A G E N D A
FARRAGUT MUNICIPAL PLANNING COMMISSION

April 21, 2016
7:00 p.m. Farragut Town Hall

SUBJECT: Discussion and public hearing on a site plan for O'Reilly Auto Parts, Parcel 36, Group B, Tax Map 143G, Zoned C-1, located at 10870 Kingston Pike, 1.04 Acres (Thornton Drive, LLC, Applicant)

Re: Staff comments on site plan for O'Reilly Auto Parts, 10870 Kingston Pike

C3.0
SHEET 8 OF 20

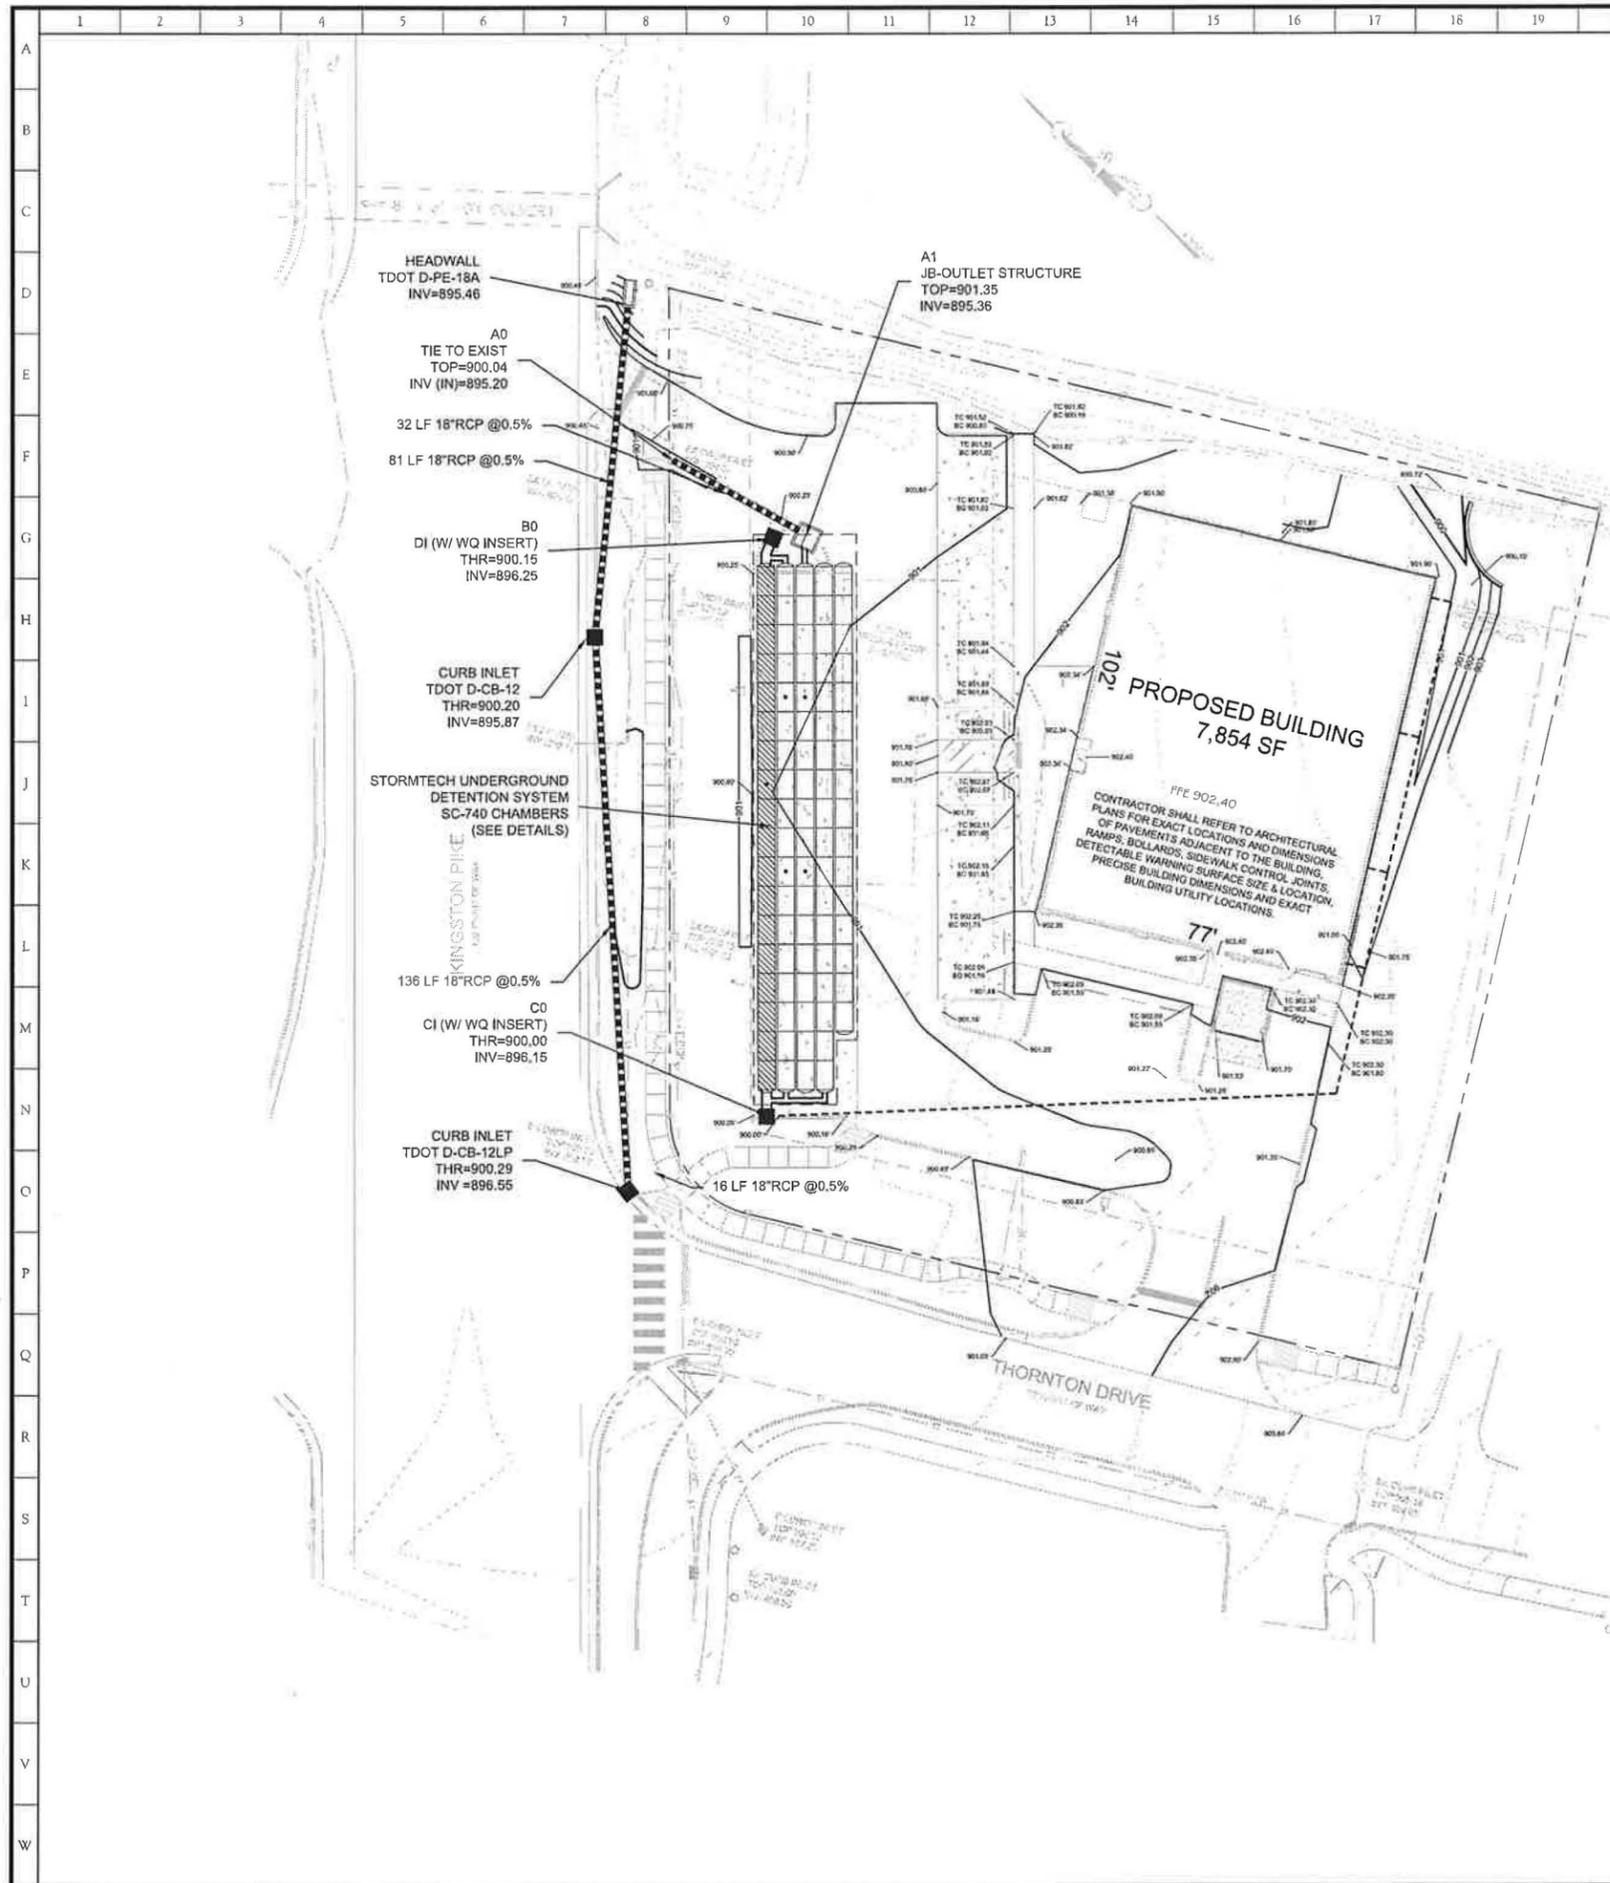
29. Check size of swale along eastern side of the site, which drains a substantial watershed from the south (toward Kingston Pike). Please confirm this drainage way will accommodate the flow.
We will not be altering the size or flow characteristics of the existing drainage swale. See sheet C3.0

- We have revised the angle of the driveway to make it more severe. Due to existing topography and drainage ways, we cannot add the short taper as discussed with Town staff. We have added the "No left turn" sign. See sheets C3.0 and C4.0.**

C4.0
SHEET 1 OF 20

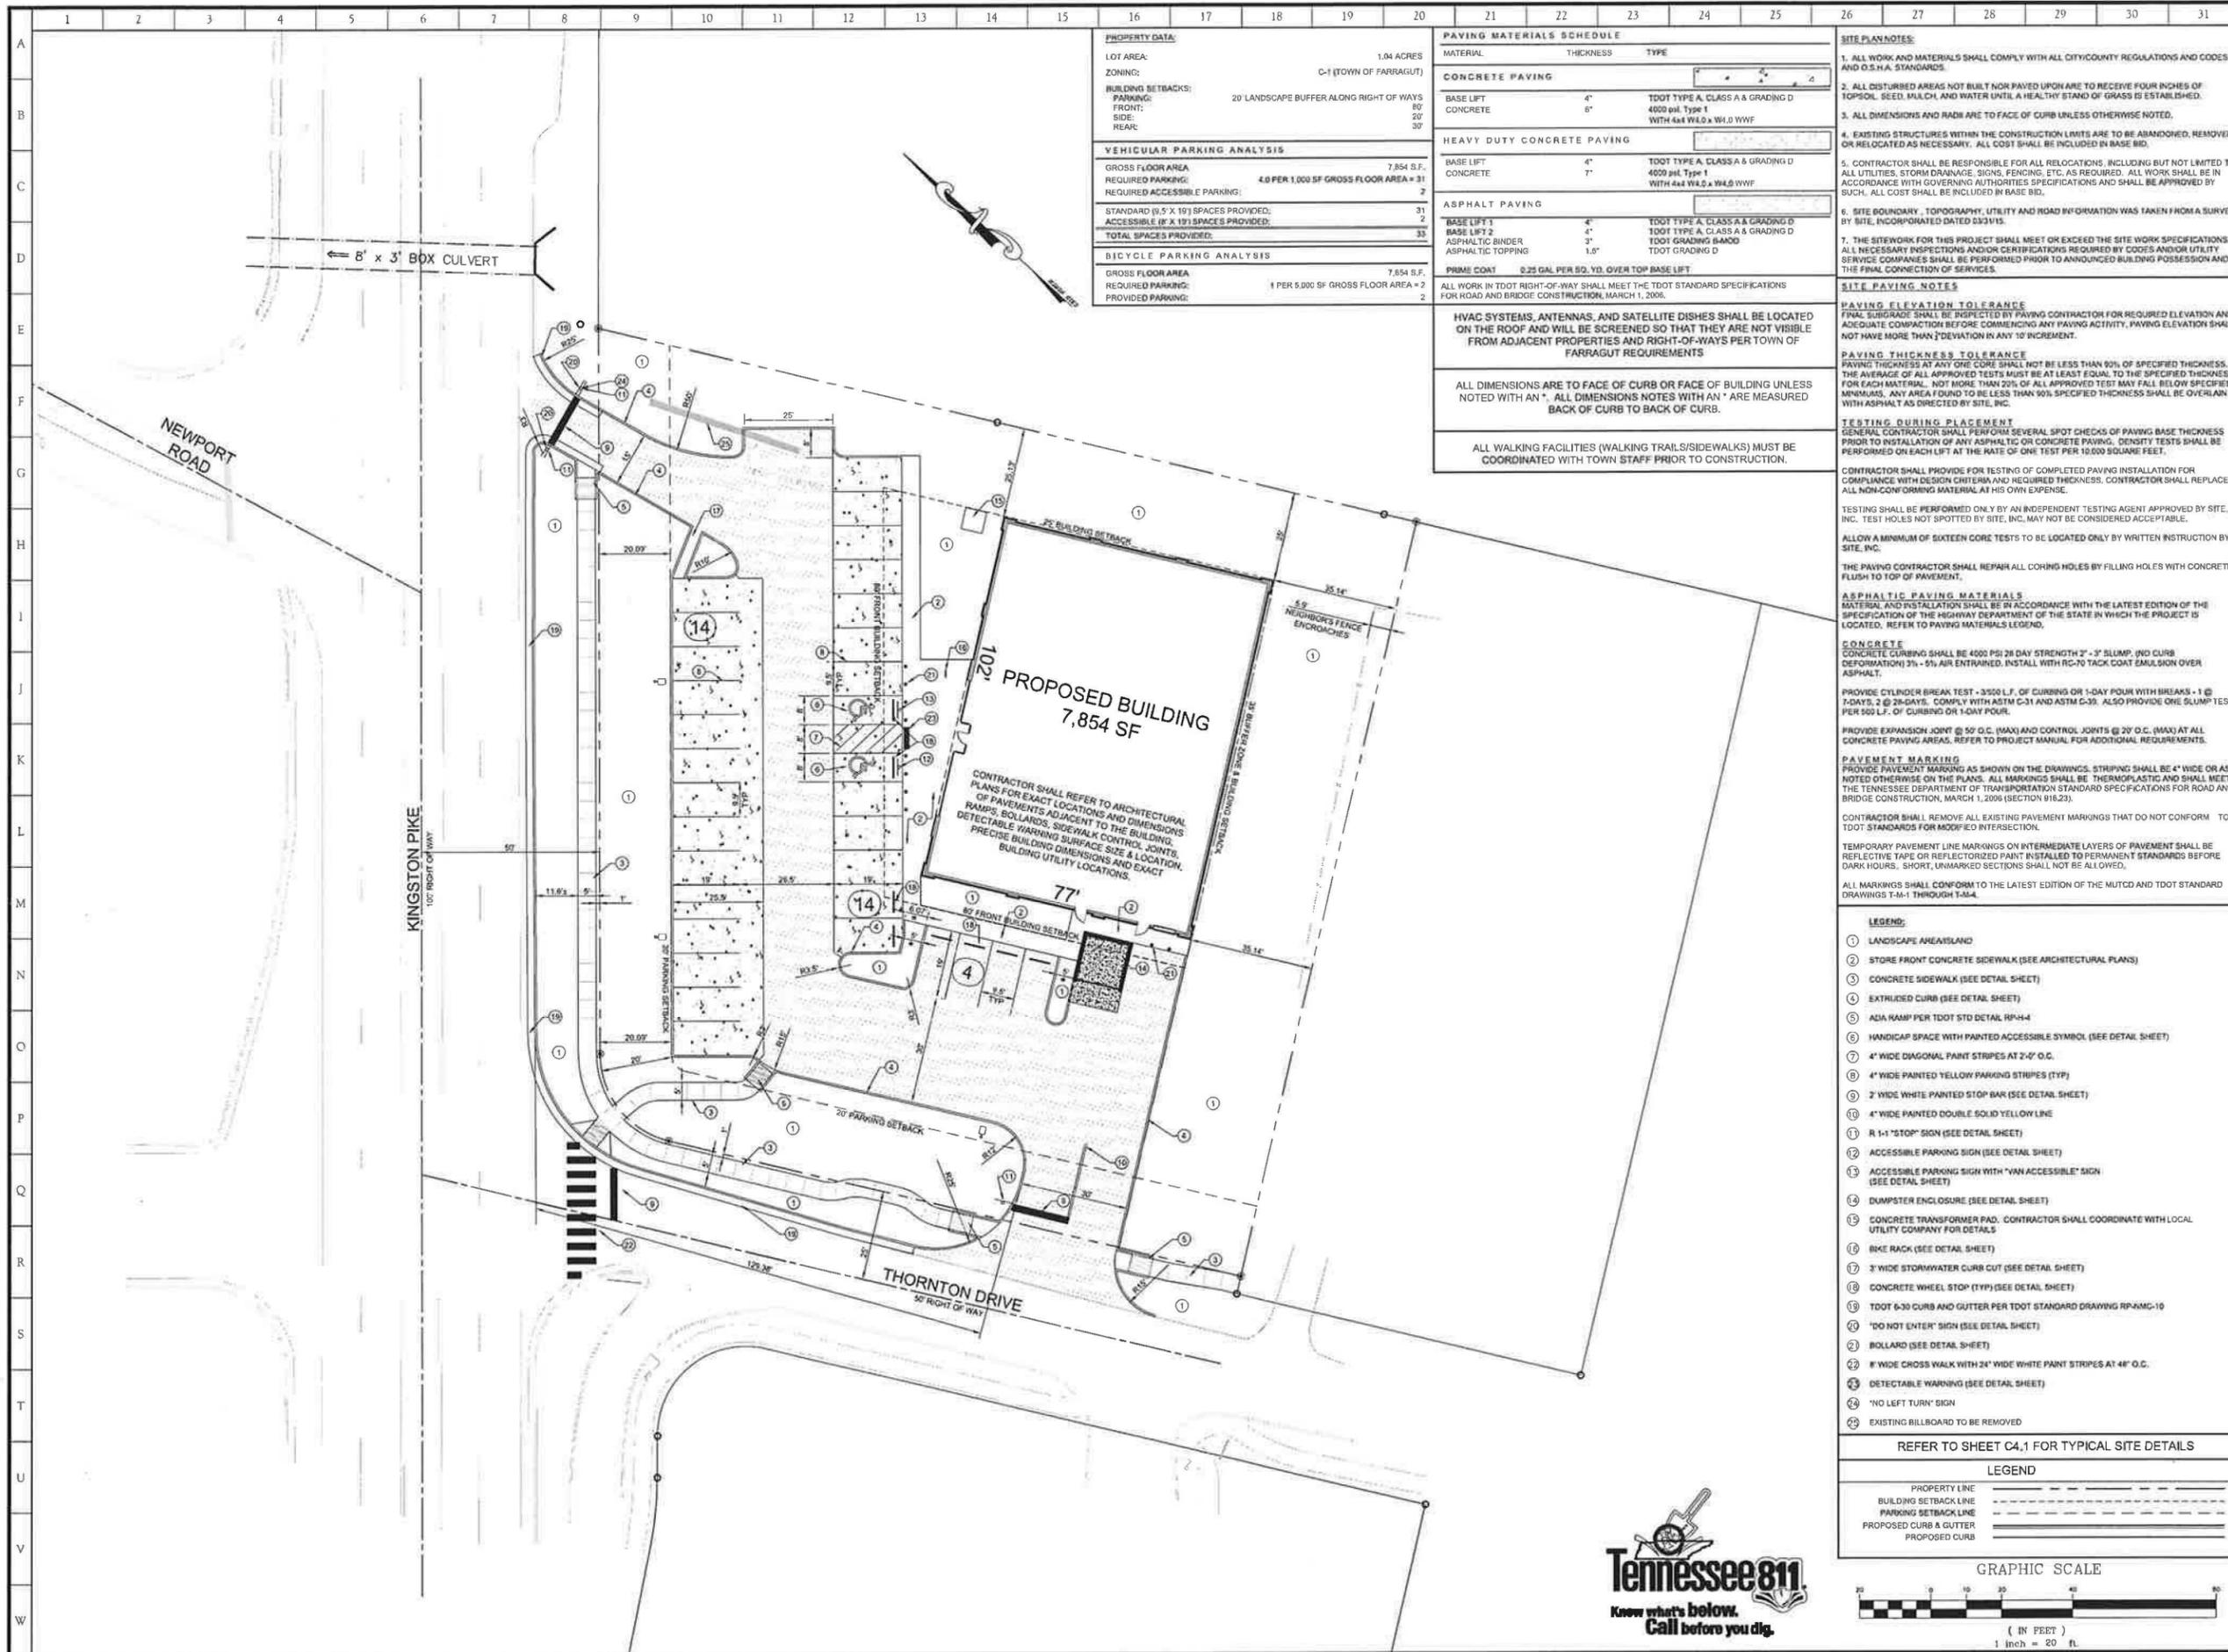
13. Please ensure that the parking lot islands (please review the pinch points) are at least 5 feet in width.
We widened the island at the northwest corner of the building to 5'. See sheet C4.0

27. Please add the following note to the site plan, "all walking facilities (walking trails/sidewalks) must be coordinated with town staff prior to construction".

Note has been added to sheet C4.0.

C6.0
SHEET 16 OF 20

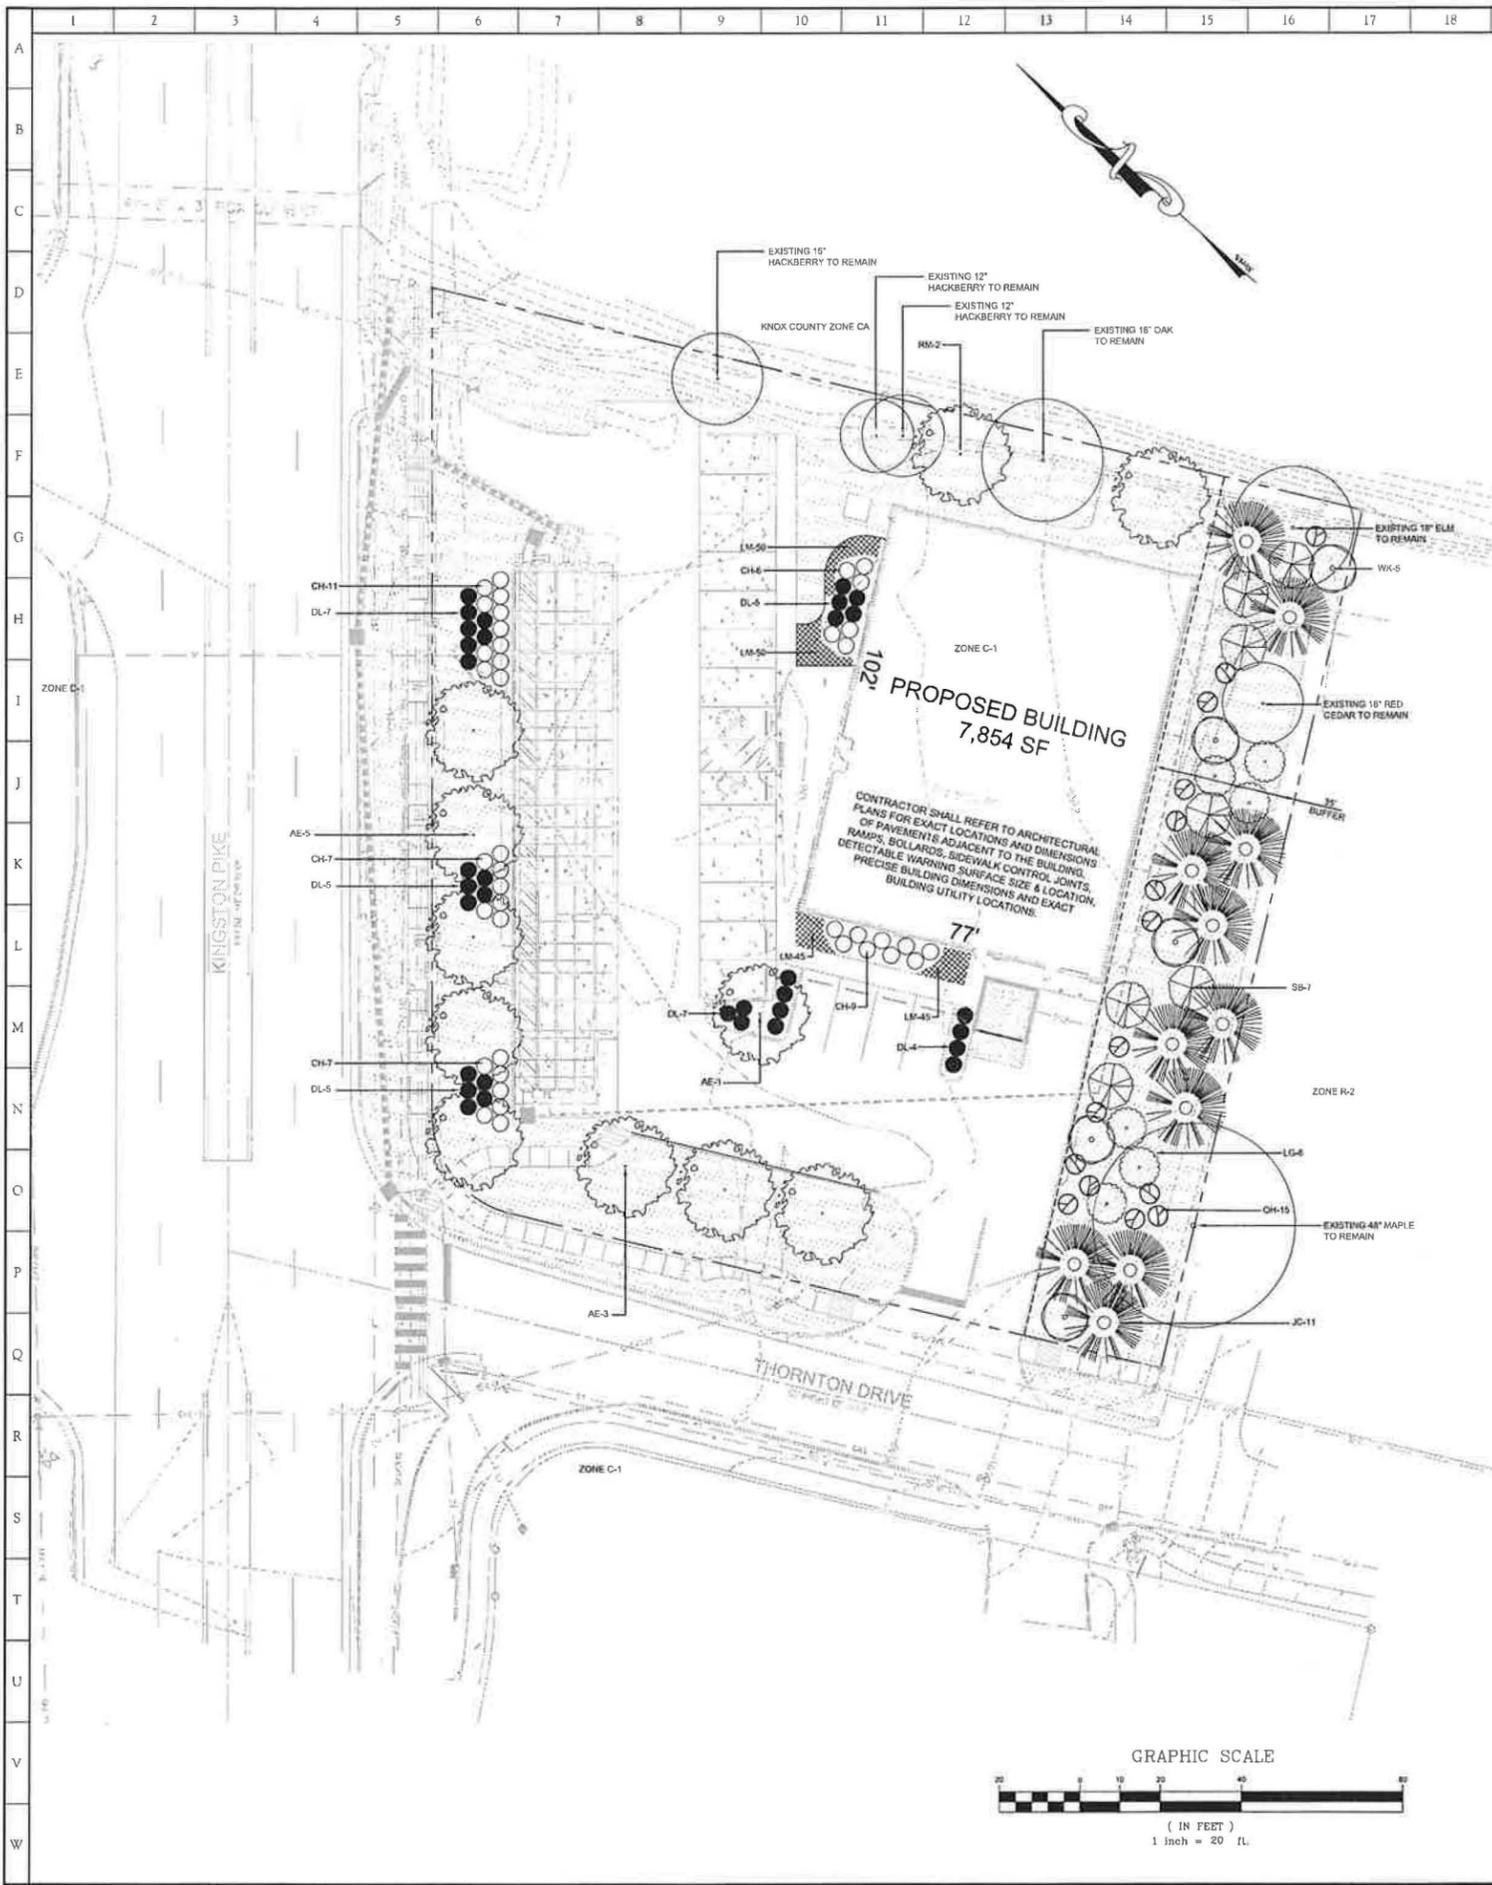
12. Consistent with Standard 1.21 of the ADS (Minimize the visual impact of surface parking), the long rows of parking should be divided into smaller pods.
Per discussion with Town staff, we have added landscaping (shrubs) along the Kingston Pike frontage to minimize the impact of the surface parking. See sheet C6.0.
